## Application for Licence Amendment

<b>Licence Number</b>	L8861/2014/1
<b>Licence Holder</b>	Karratha Recycling Pty Ltd
<b>ACN</b>	163 991 106
<b>File Number</b>	DWERVT16174~1
<b>Premises</b>	<p>Karratha Recycling Liquid Waste Facility Lot 120 and 121 Pindan Road</p> <p>GAP RIDGE WA 6714</p> <p>Legal description: Lot 120 on Deposited Plan 424552 Certificate of Title Volume 4027 Folio 393; and Lot 121 on Deposited Plan 424552 Certificate of Title Volume 4027 Folio 394</p> <p>As defined by the Premises map attached to the Revised Licence</p>
<b>Date of Report</b>	20 December 2024
<b>Decision</b>	Revised licence granted

**Figure 1: Pond layout - Anaerobic Pond (T.P.4) and Aerobic Pond (T.P.5)**

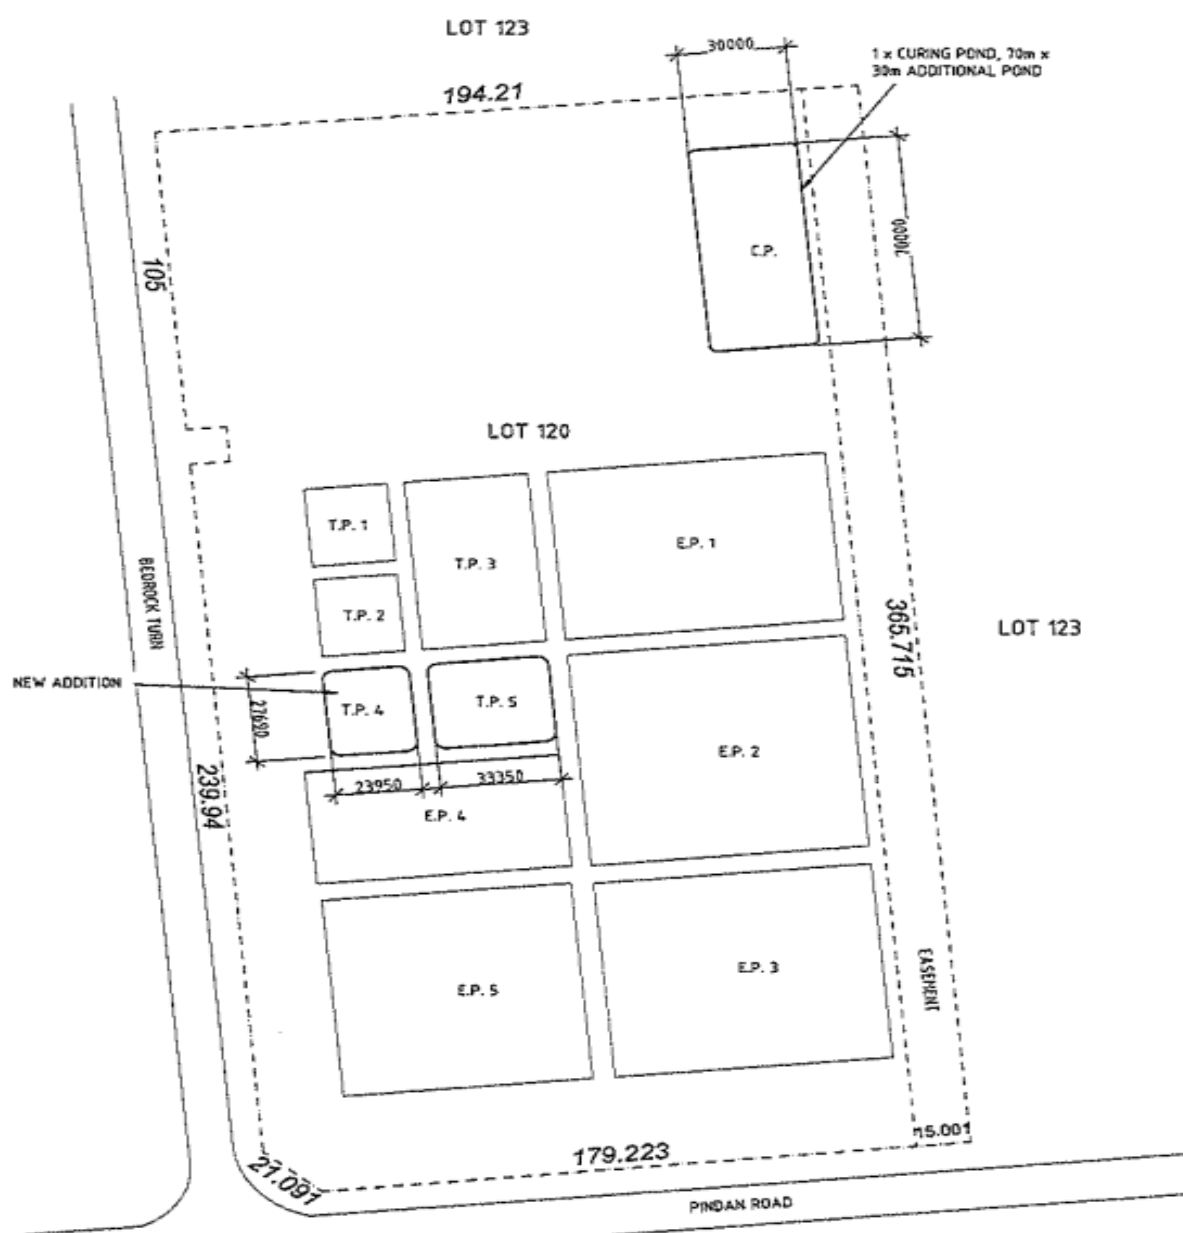
Infrastructure	Design and construction / installation requirements	Conformance with requirements
Ponds As defined on Figure 1	<ul style="list-style-type: none"> <li>Anaerobic pond of 27.69m x 23.95m and Aerobic pond 27.69m x 33.35m and 3 m in depth;</li> <li>Lined with Elcoseal GCL with a permeability great then <math>1 \times 10^{-9}</math> m/s;</li> <li>Compacted base of in-situ soil;</li> <li>Moisture condition and compact to Standard Maximum Dry Density (SMDD) of 95% and Optimum Moisture Content (OMC) of -2% to +2% in layers to FSL not exceeding 300mm and not less than 100mm;</li> <li>Internal batters cut to 1:3 (V:H);</li> <li>The entire surface area of each roll must be inspected by the suitably qualified CQA civil engineer/consultant prior to works commencing or during unrolling/installation, to ensure that there are no tears, punctures, abrasions, indentations, cracks, thin spots or other faults in the material;</li> <li>Installation and seaming must be undertaken by installers with extensive experience in seaming the same type of GCL being installed and using the same seaming procedures to be used on site. They must hold a current independent certification for seaming and installation to a recognised industry standard (national or international);</li> <li>Must be installed to overlay the subgrade so that the GCL remains in direct contact with the subgrade, with sufficient slack given to ensure low areas in the subgrade are not bridged by the GCL;</li> <li>Panel overlap zones must be no less than 300 mm and orientated so the overlap is in the down sloping direction</li> </ul>	<ul style="list-style-type: none"> <li>The ponds have been constructed to fall within the specified dimensions;</li> <li>The in-situ soil of the Pond areas was compacted;</li> <li>The Ponds have been lined with GCL Liner;</li> <li>A CQA has been submitted for the Ponds to demonstrate that liner installation was completed with no material faults and as per the required specifications;</li> <li>Pond Inspection and Test Plan has been submitted which has been signed by authorised officers advising: <ul style="list-style-type: none"> <li>Base layer material was sufficient;</li> <li>Field Density 90% MMDD have all been exceed;</li> <li>Batter slopes were completed;</li> <li>No non-conformance with GCL liner rolls;</li> <li>GCL Rolls placed correctly; and</li> <li>No GCL repairs were required.</li> </ul> </li> <li>The Ponds have been lined with GCL Liner;</li> <li>Anchor trenches completed as required;</li> <li>Soil placement over GCL completed as required;</li> <li>The water table at the Pond location varies between 9-10 mBGL according to sampling results obtained from an adjacent groundwater monitoring bore. The base of the GCL installed are therefore approximately 6-9m from</li> </ul>

Infrastructure	Design and construction / installation requirements	Conformance with requirements
	<p>and across the pond base;</p> <ul style="list-style-type: none"> <li>• Panels installed on Ponds embankments must be fixed in anchor trenches. Anchor trenches must be set back 1.0 m from the top edge of the pond embankment and slopes steeper than 7H : 1V;</li> <li>• Panels must be free of holes, blisters, blemishes, striations, bubble, roughness, contaminants and permanently attached raw materials;</li> <li>• Where the GCL has been damaged during installation, covering with an overlapping piece of GCL can repair such areas. The overlap should be at least 500 mm;</li> <li>• Document the results of the installation of the GCL Liner, inspection, and if required, any repairs done to the liner;</li> <li>• 300mm soil placement over the GCL;</li> <li>• Lined in accordance with the specifications of Water Quality Protection Notice (WQPN) 26, <i>Liners for containing pollutants, using synthetic membranes</i> (Department of Water, August 2013);</li> <li>• Separation distance of at least 2 m must be maintained between the base of the GCL and the highest wet season water table;</li> <li>• Perimeter of Ponds must be bunded;</li> <li>• Constructed to contain rainfall resulting from a 1 in 100 year storm event of 24 hours duration; and</li> <li>• Constructed to allow for a 500 mm freeboard to be maintained.</li> </ul>	<p>the water table;</p> <ul style="list-style-type: none"> <li>• The perimeter of the Ponds are bunded;</li> <li>• The Ponds capacity to contain rainfall resulting from a 1 in 100 year storm event of 24hrs duration;</li> <li>• Ponds allow for a 500 mm freeboard to be maintained; and</li> <li>• Construction photographs have been submitted.</li> </ul>
